Hi-Fi Products Service Bulletin

Model: TA-AV531, TA-AV631X

No. 452

Subject: Resistors Missing on Main PC Board

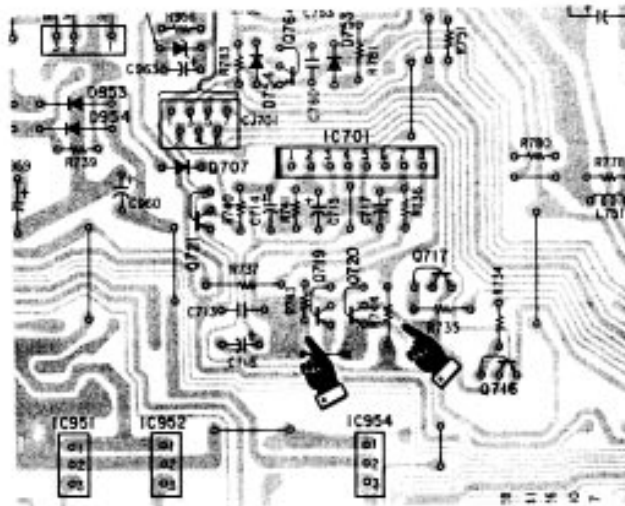
During the production phase of the TA-AV531 and TA-AV631X, R743 and R744 may not have been installed* on the Main PC board.

When a TA-AV531 or 631X is in for service, for any reason, verify that R743 and R744 have been mounted on the main board. If not already installed, mount the resistors on the board. If you must replace the Main PC board on either of the above models, check the board for missing resistors before installing. The part numbers for the main boards are A-4360-464-A (TA-AV531), and A-4365-074-A (TA-AV631X). The resistor part numbers are listed below.

REF	DESCRIPTION	PART NUMBER
R743	47K OHM RESISTOR	1-249-465-11
R744	3.3K OHM RESISTOR	1-247-719-11
